STAFF REPORT

ITEM: Bentley Village Sketch Plan Review

BENTLEY VILLAGE - SKETCH PLAN SUBMITTAL
LAKE ELMO, MINNESOTA

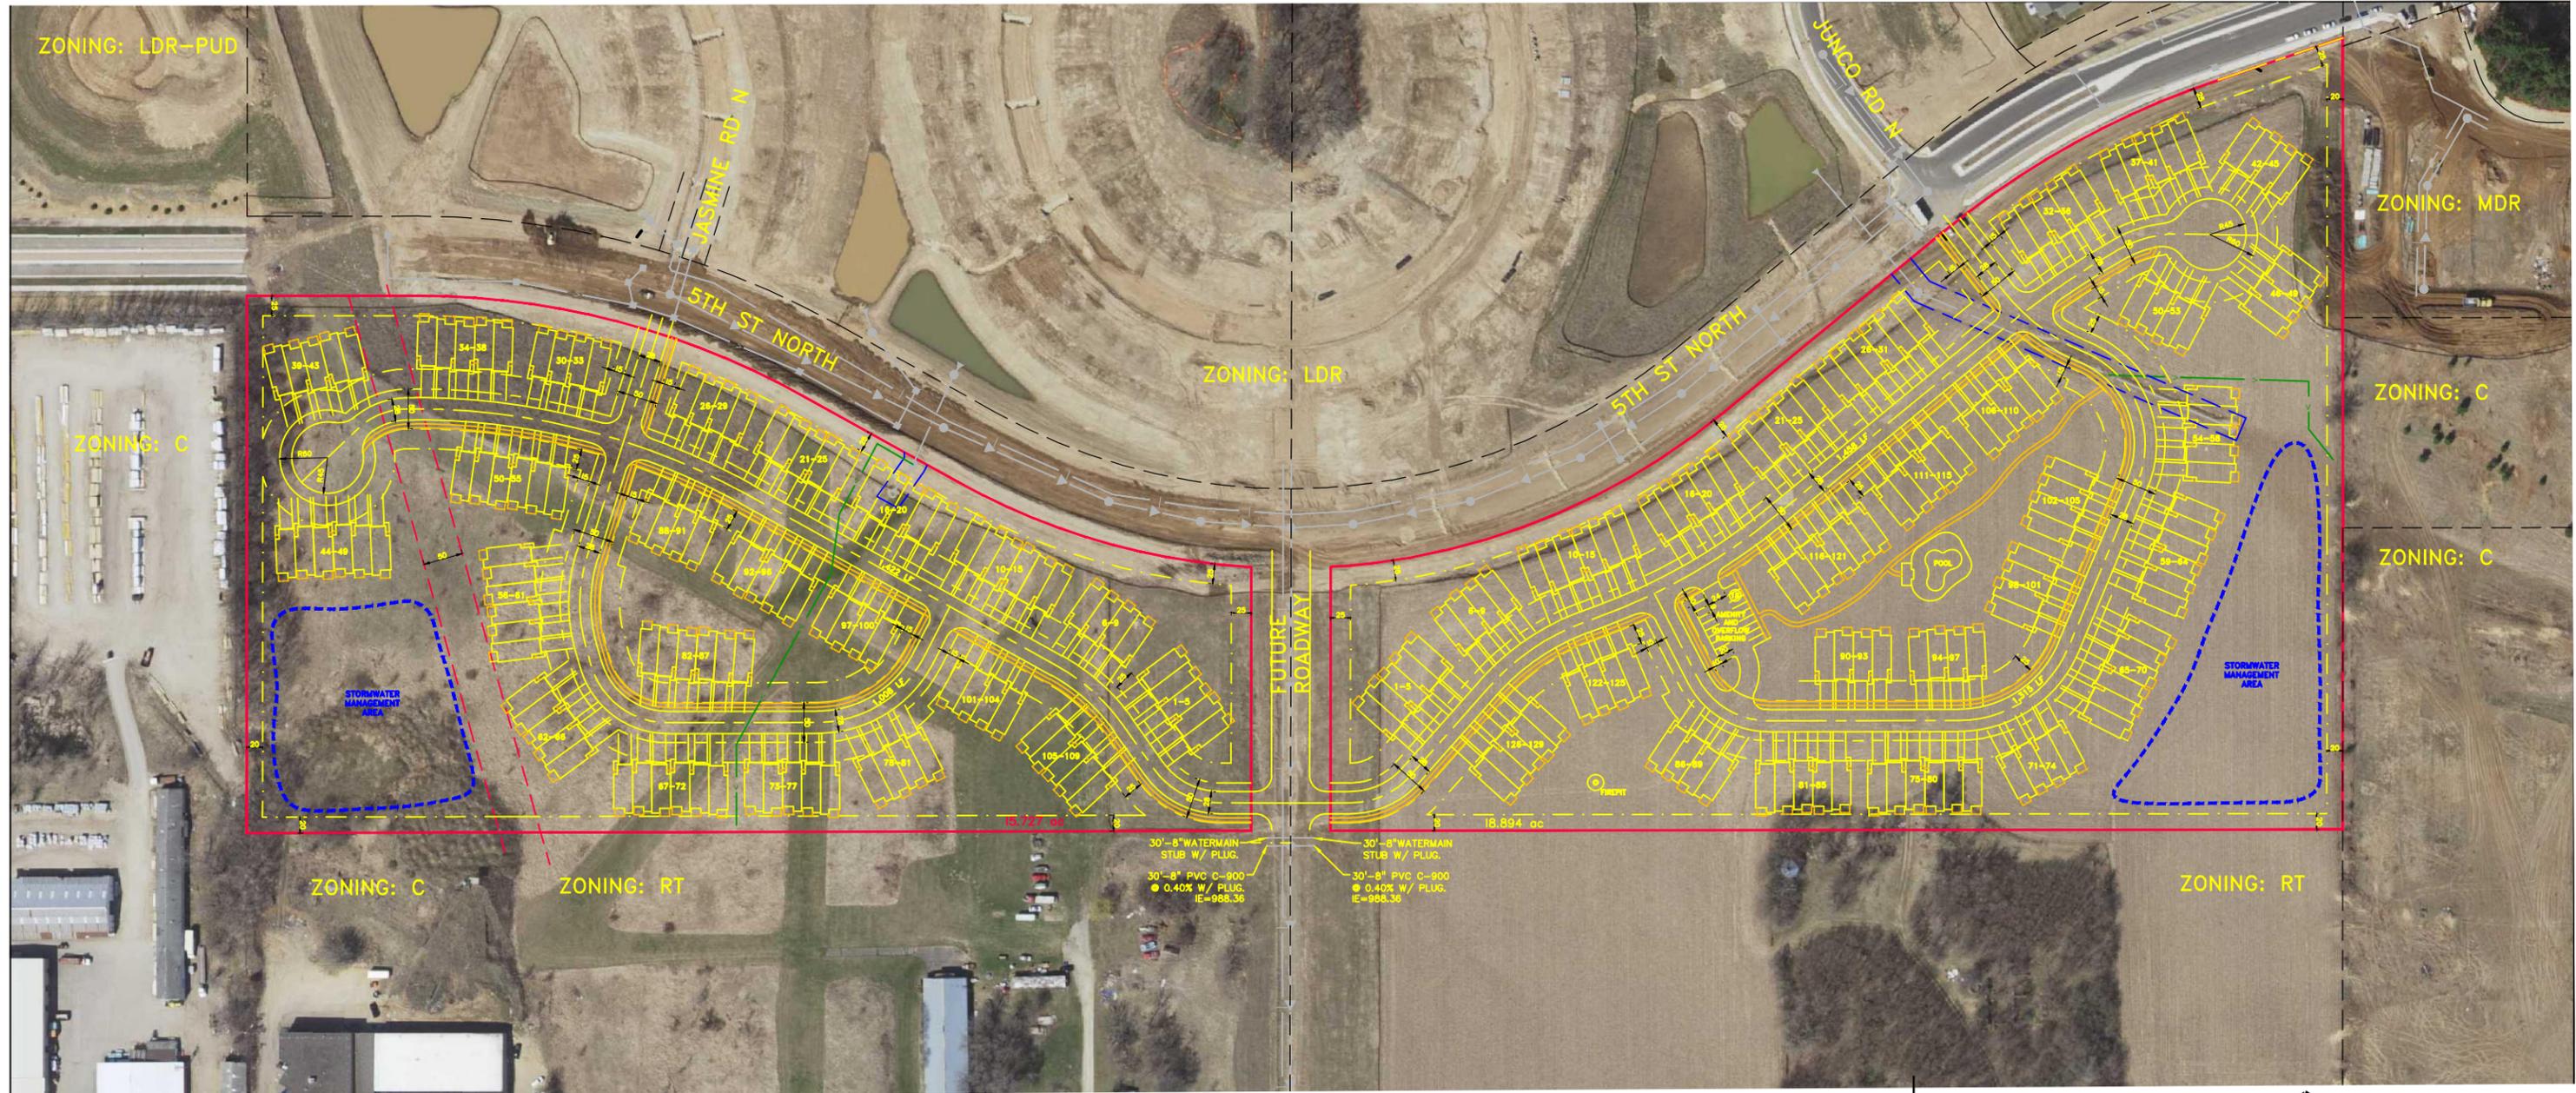
Density. The proposed development includes 239 units. The site is a total of 34.621 acres with no wetland, proposed parkland, or arterial right-of-way. The net density is therefore 6.9 units per acre. This meets the density requirements for the Urban Medium Density land use of 4.5-7 units per acre.

Trails. Sidewalks are being proposed on one side of each street, and it appears that there is a proposed trail connecting two streets within the open space on the east side of the development. Additionally, the City's trail plan indicates a trail connecting 5th Street North to Hudson Boulevard North, and so a trail should be provided on the street connecting these aforementioned streets.

Restrictive Easements. There is a 50-foot wide natural gas pipeline easement that bisects the western portion of the property in which buildings cannot be placed. There are no lots proposed within this easement. There is also a 21-inch diameter storm sewer pipe with a 30-foot wide easement on the eastern edge of the property. The sketch plan results in some of this storm sewer and easement to remain in place and some to be realigned.

1. Common open space for use by all residents or private open space adjacent to each unit shall be provided. Such open space shall comprise a minimum of 500 square feet per unit.
 - *A minimum of 539 square feet is provided per unit.*
